# Nuclear Safety

## Advisory Letter

Subject: <b>Barton Model 763, 763A and 764 Transmitters With Defective External Lead Wire Connectors</b>	Number: NSAL-06-13
Basic Components: Barton Model 763 and 763A Gauge Pressure Transmitters and Model 764 Differential Pressure Transmitters	Date: 10/24/2006
Affected Plants: All plants using Barton Model 763, 763A or 764 transmitters	
Substantial Safety Hazard or Failure to Comply Pursuant to 10 CFR 21.21(a)	Yes <input type="checkbox"/> No <input type="checkbox"/>
Transfer of Information Pursuant to 10 CFR 21.21(b)	Yes <input type="checkbox"/>
Advisory Information Pursuant to 10 CFR 21.21(d)(2)	Yes <input checked="" type="checkbox"/>
References: See page 10

**Figure 1: Connector Assemblies That Do and Do Not Need to be Inspected**

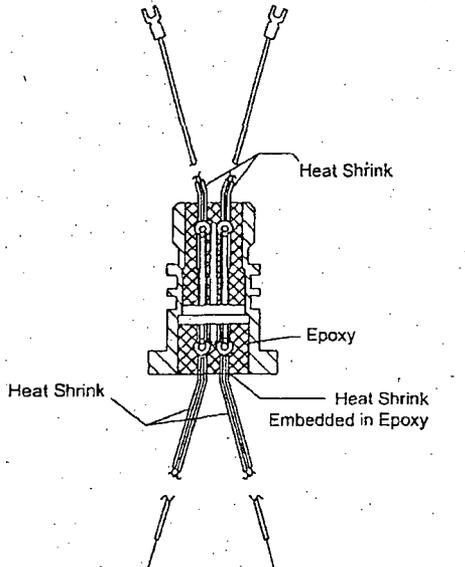
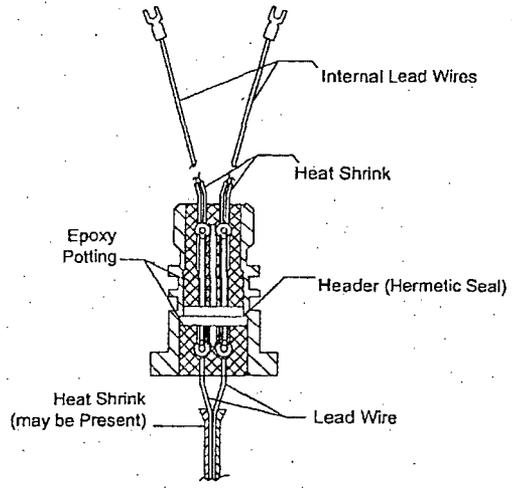
This Configuration should NOT be subjected to the inspection/bend test!

**Connector  
(Pre-June 1982)**

External Lead Wires  
Note: Heat Shrink may be Placed Over Individual Leads

**Connector  
(Post-May 1982)**

For connector assemblies that are installed on transmitters that could be subjected to a potential harsh environment associated with a LOCA or HELB environment and include installations that do not include environmentally sealed conduit connectors, Westinghouse recommends that customers replace the external lead wire connector assemblies manufactured and supplied after May 1982 and before June 1, 2006 during their next scheduled outage after parts are available. The inspection defined in Reference 1 is not required, since Westinghouse is recommending replacement of all post-May 31, 1982 connector assemblies in these specific installations. Westinghouse also recommends that the licensee evaluates the potential impact on the safety-related functions provided by Westinghouse qualified Barton Model 763, 763A and 764 transmitters.
